Instruction for hydraulic pump

V-30225110 & V-30225120

ANV020

Hydraulic pump V-30225110

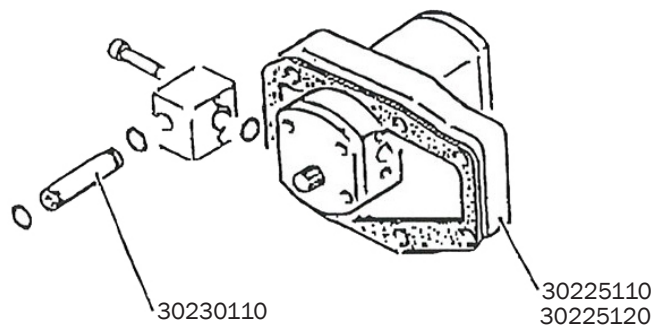
The type of hydraulic pumps delivered as spare parts has changed. The spare part numbers of the pumps are the same as before.

Tractors up to chassis number 607100:

If the pump is of a new type is installed instead of the old a connection pipe must also be delivered.

Connection pipe V-30230110

As the new pumps are slightly longer than before, in some cases the PTO guard and the top rod bracket must be modified so that the pump can be installed in position.
